**HUGHES
SERVICE INFORMATION
NOTICE**

NOTICE NO. N-31.1*

**SUBJECT: FIELD INSTALLATION AND MODIFICATION - DUAL BOLT
TAIL SKID MOUNTING HARDWARE**

MODELS AFFECTED: All Model 269 Series Helicopters

Figure 1. Field Installation and Modification - Dual Bolt Tail Skid Mounting Hardware

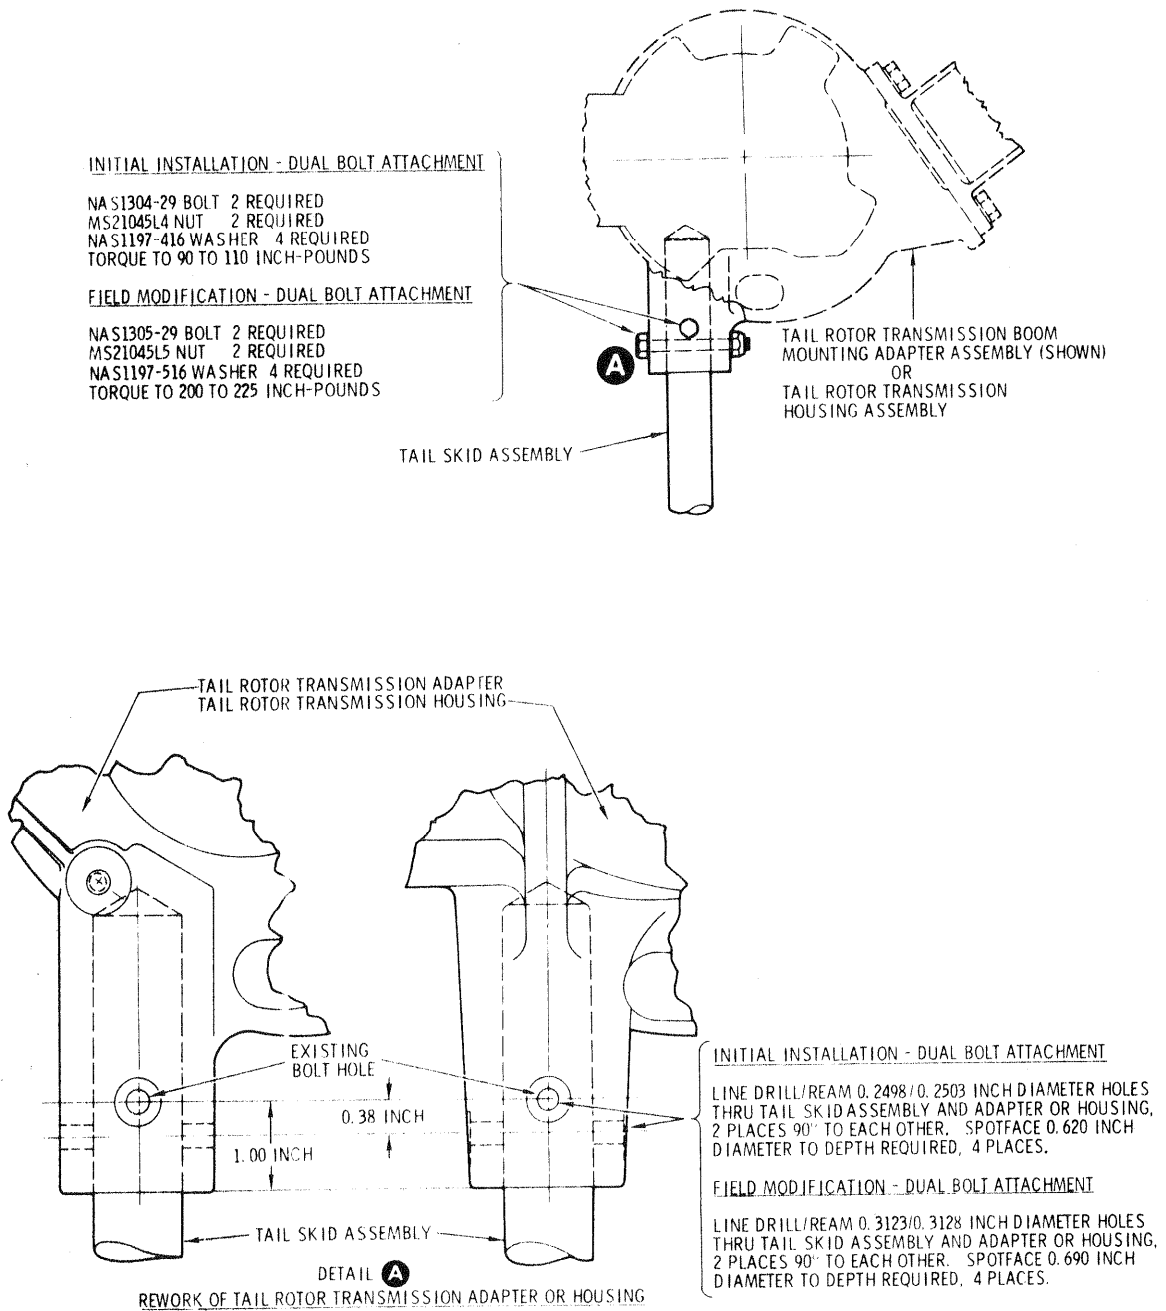
PREFACE: Part I of this Notice lists a procedure for installing dual bolt tail skid mounting hardware on early model helicopters, to provide increased support for the tail skid assembly.

Part II of this Notice lists a procedure for modifying existing dual bolt tail skid mounting installations, as required, to eliminate looseness of the tail skid in the transmission housing or adapter.

Close tolerance bolts and specific bolt torque requirements are now utilized for both new and modified dual bolt mounting installations, to ensure positive attachment of the tail skid assembly.

- a. With tail skid installed, line drill 0.2480 inch diameter hole through tail skid and tail rotor transmission adapter or housing below existing hardware at dimensions shown in Figure 1.
- b. Hand ream holes to 0.2498/0.2503 inch diameter; spotface 0.620 inch diameter to depth required to clean up to 0.500 inch wide surface, two places, on adapter or housing. Touch up reworked areas with corrosion preventive coating.
- c. Install new NAS1304-29 bolt, NAS1197-416 washers and MS21045L4 nut; apply wet zinc chromate primer before installation. Direction of bolt head is optional; washer required under bolt head and nut.
- d. Torque new NAS1304-29 bolt to 90 to 110 inch pounds.
- e. Remove original tail skid attachment bolt, washers and nut; repeat steps b thru d above for remaining tail skid attachment bolt.
- f. Check new dual bolt tail skid mounting installation for discrepancies.

- a. Remove one of the two existing tail skid attachment bolts, washers and nuts.
- b. Line drill through holes in tail skid assembly and tail rotor transmission adapter or housing, using 0.3110 inch diameter drill.
- c. Hand ream holes to 0.3123/0.3128 inch diameter; spotface to 0.690 inch diameter to depth required to clean up to 0.500 inch wide surface, two places, on adapter or housing.
- d. Touch up all reworked areas with corrosion preventive coating.
- e. Install new NAS1305-29 bolt, NAS1197-516 washers, and MS21045L5 nut. Apply wet zinc chromate primer before installation. Direction of bolt head is optional; washer required under bolt head and nut.

- f. Torque bolt to 200 to 225 inch pounds.
- g. Repeat steps a thru f above for remaining tail skid attachment bolt.
- h. Check modification of dual bolt tail skid mounting installation for discrepancies.
